ADDENDUM NO. 1

Water, Sewer, paving, Drainage, and Street Light Improvements to serve
South Oak Grove Estates, Section Six
CITY PROJECT NO.: 102739

Bid Date: January 14, 2021
Addendum No. 1: Issued January 8, 2021

FORT WORTH CITY OF FORT WORTH, TEXAS
EXPANSION JOINT
REVISED: 08-31-2012
32 13 13-D513

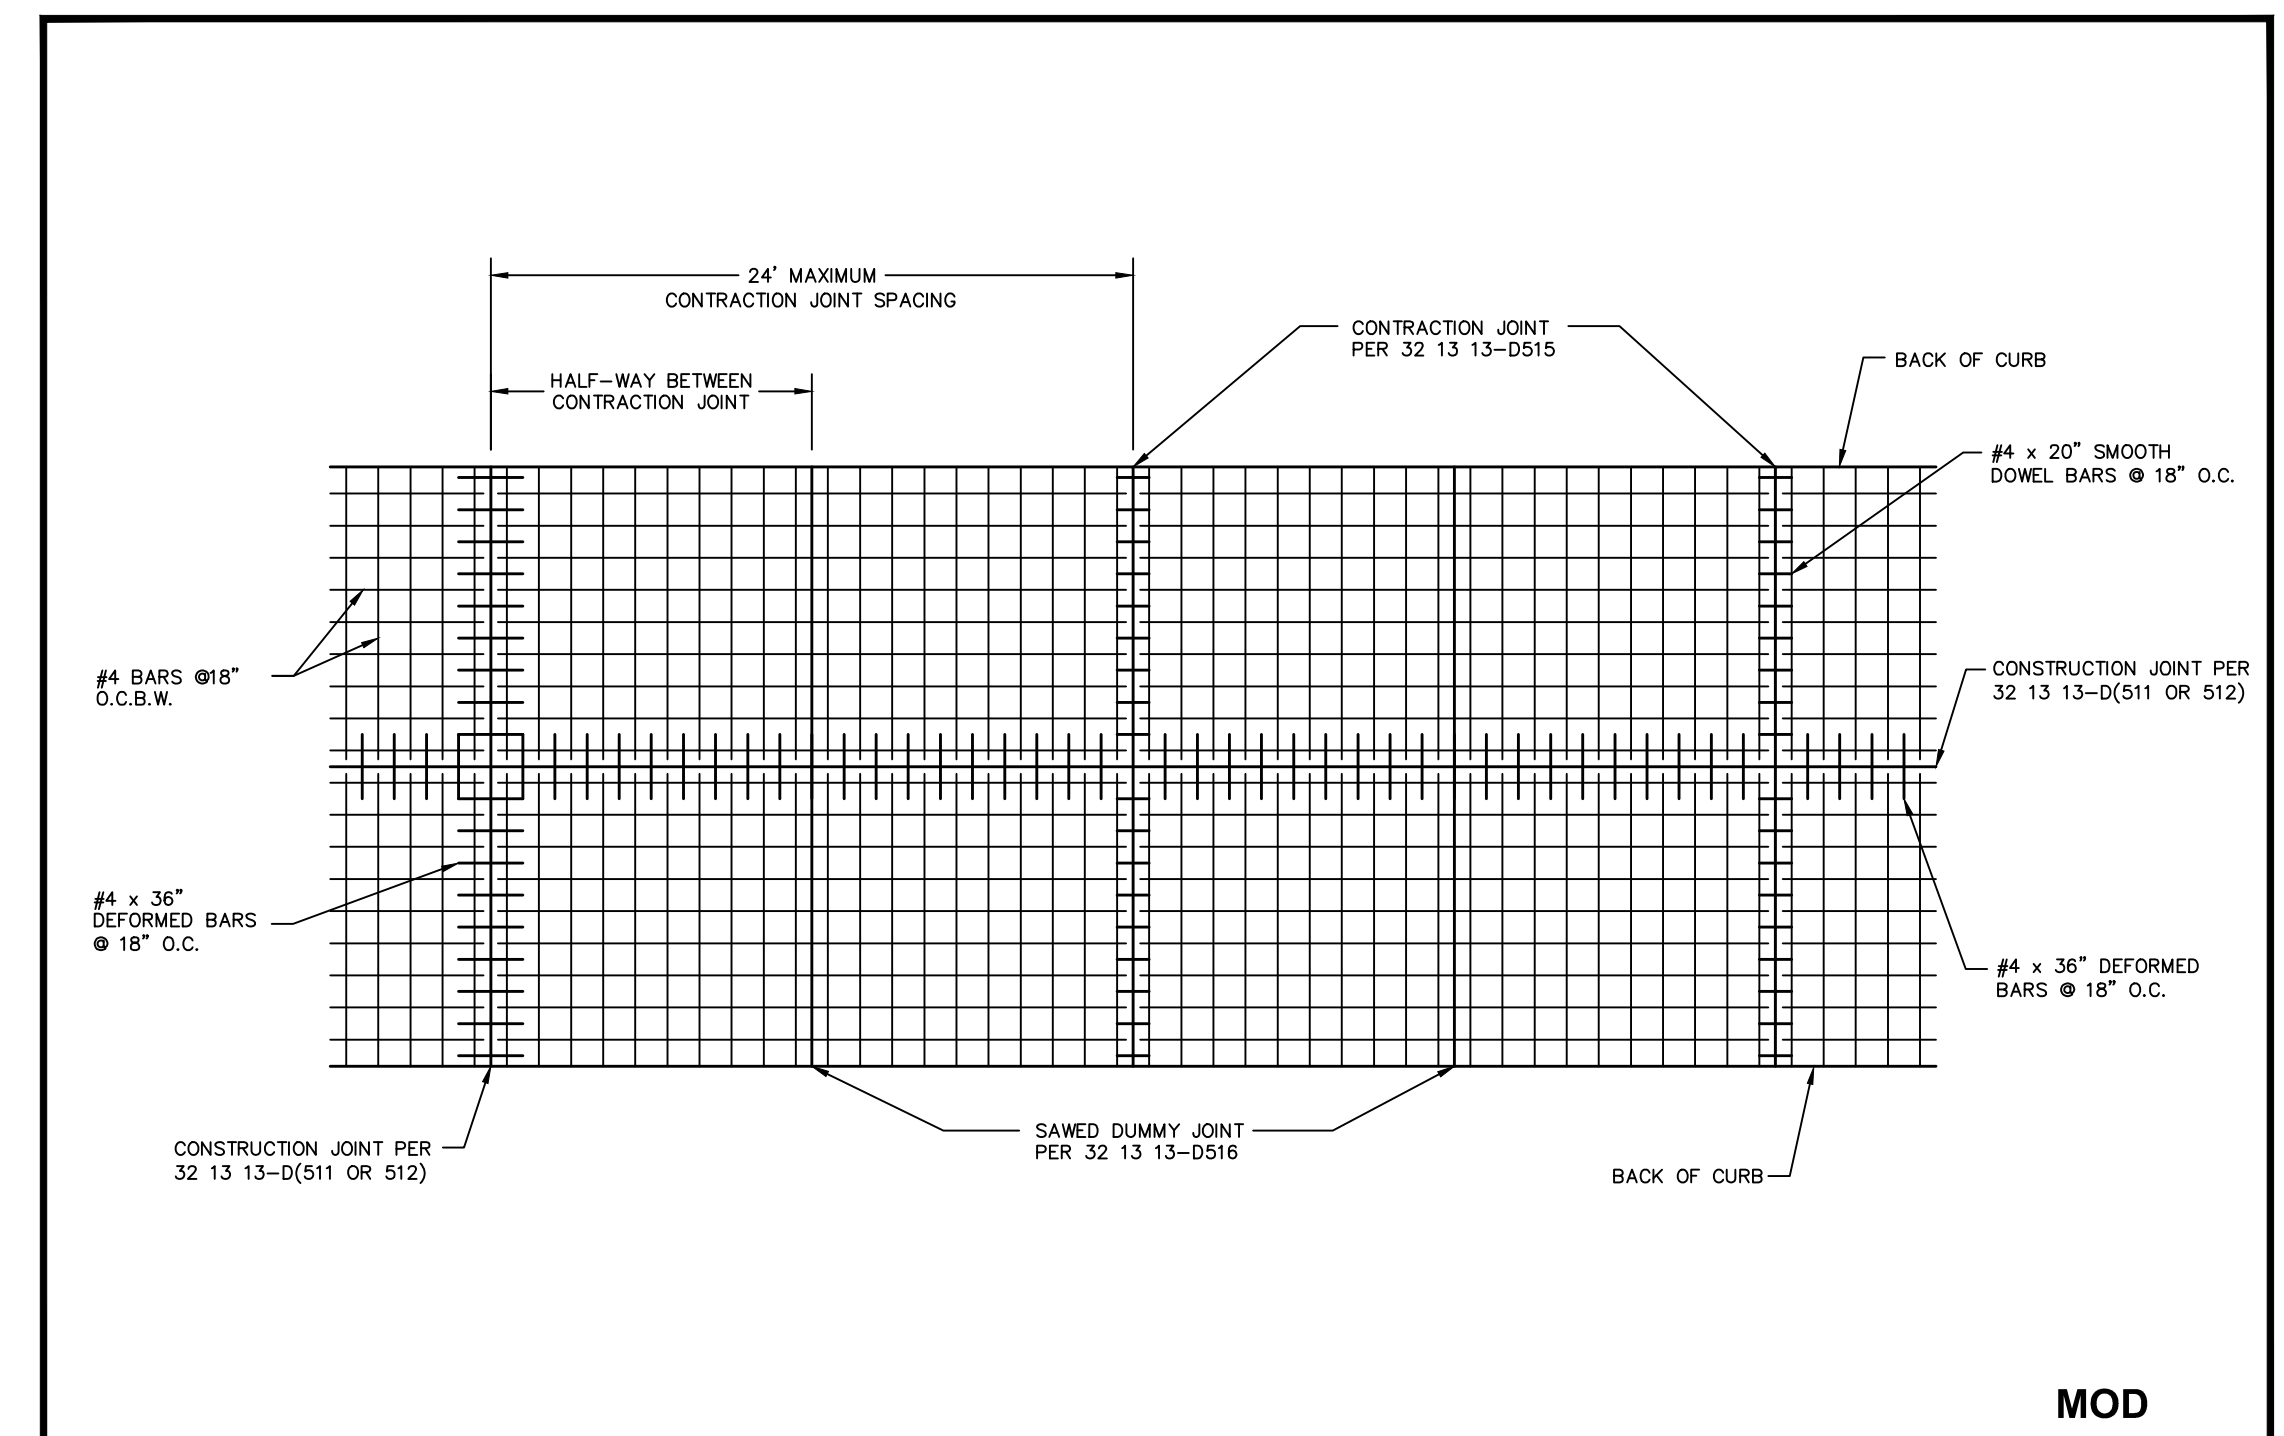
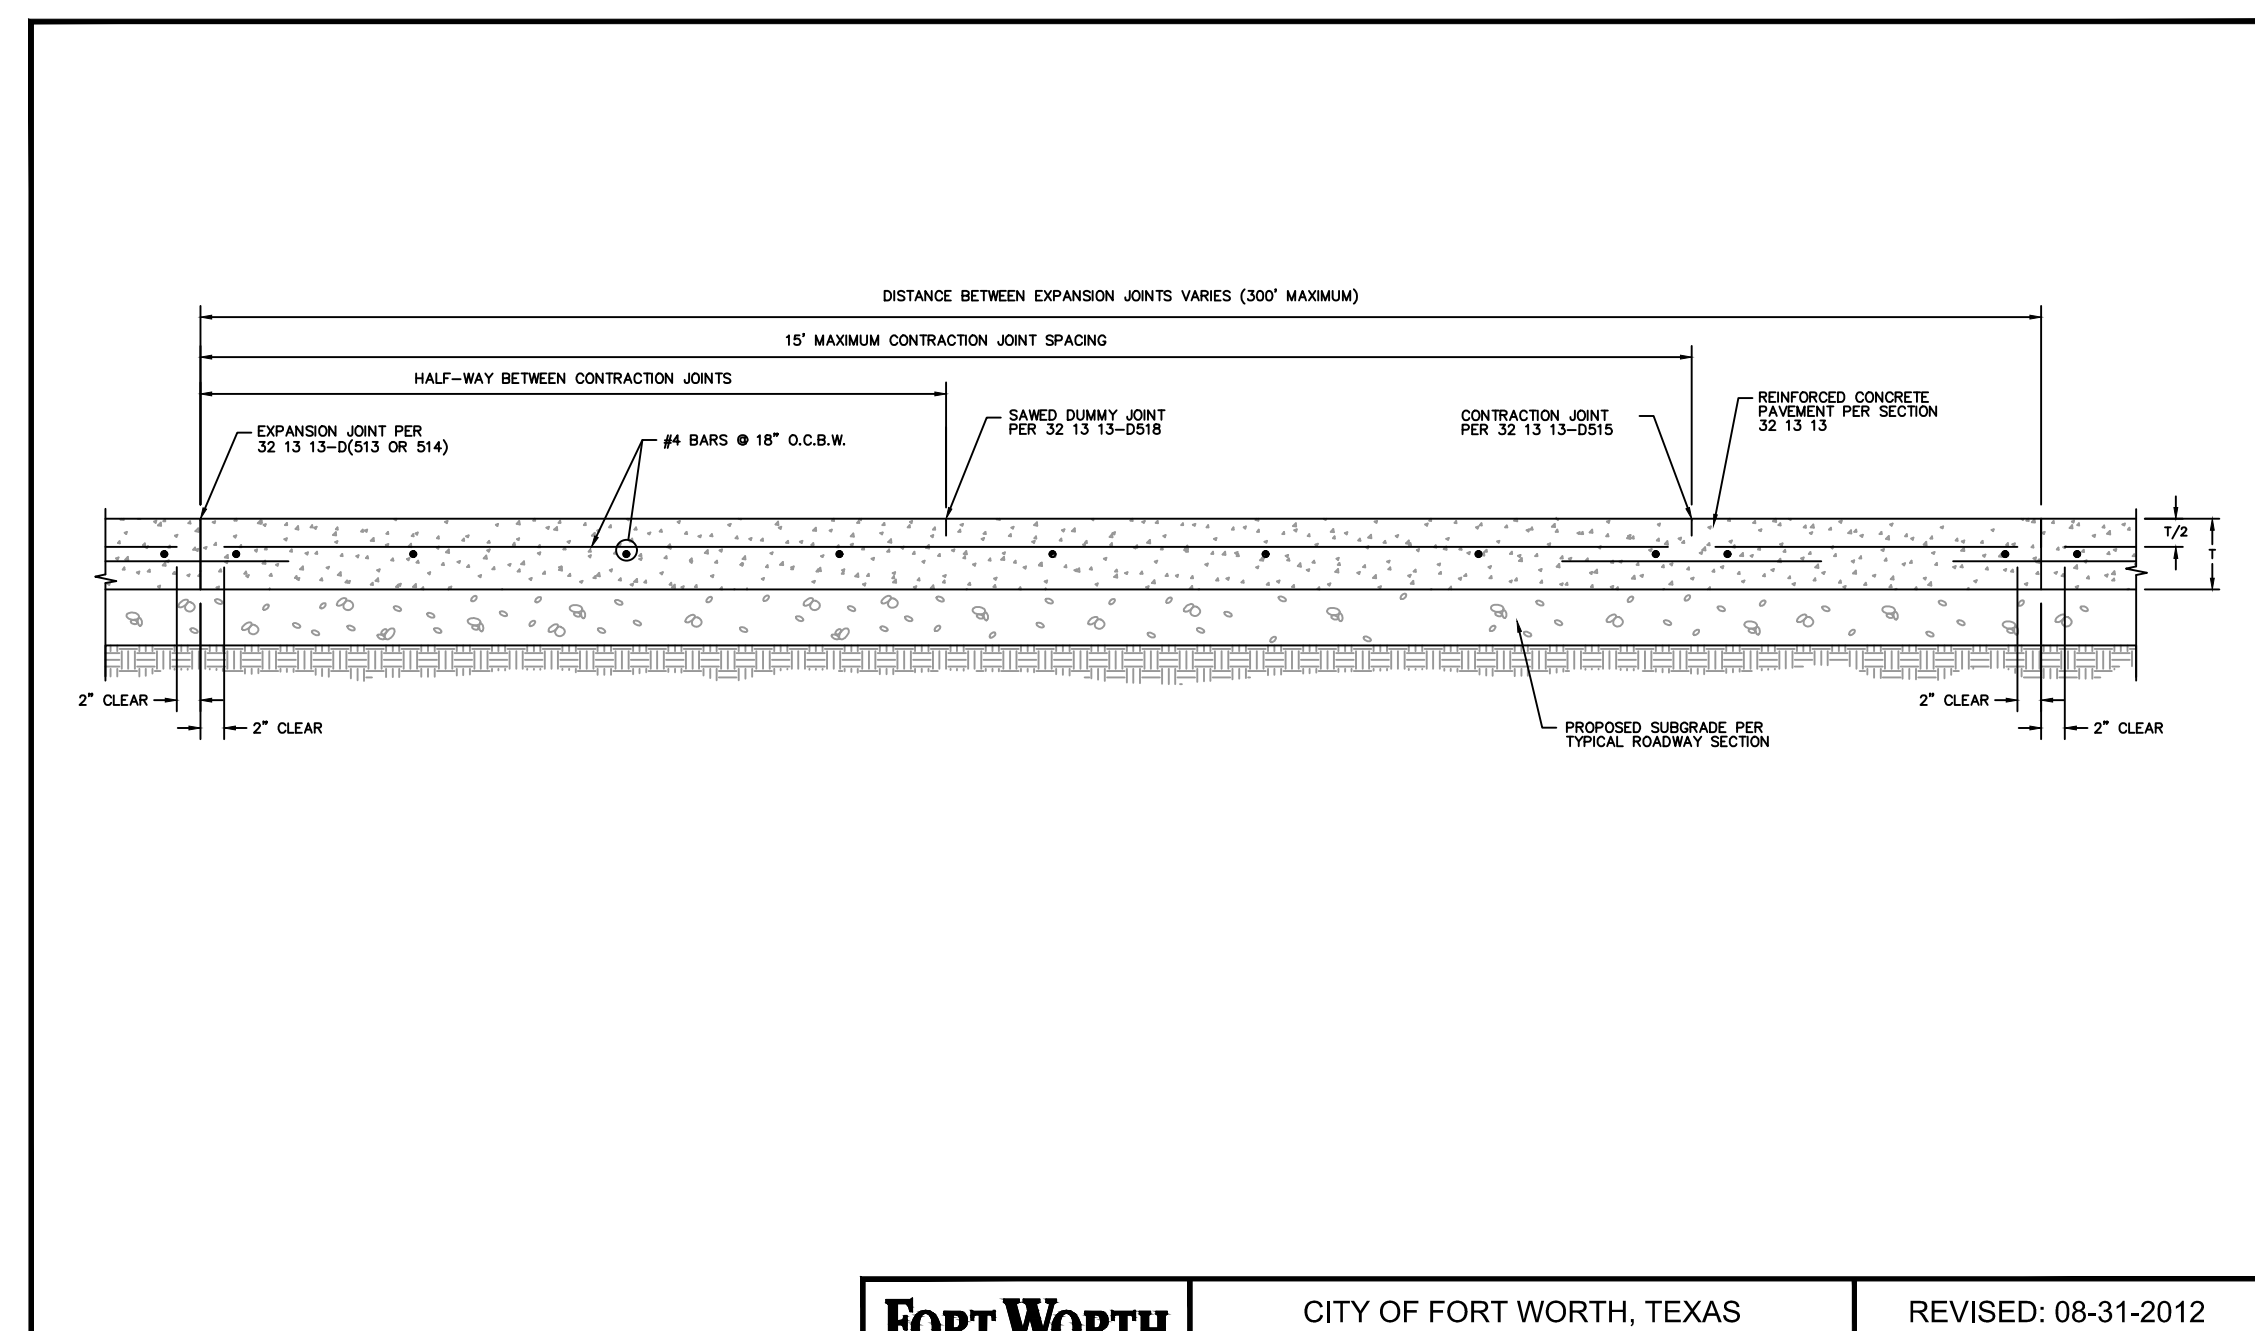
Sheet 21	Modified the lime stabilization construction note.
Sheet 27	Modified contraction joint spacing.
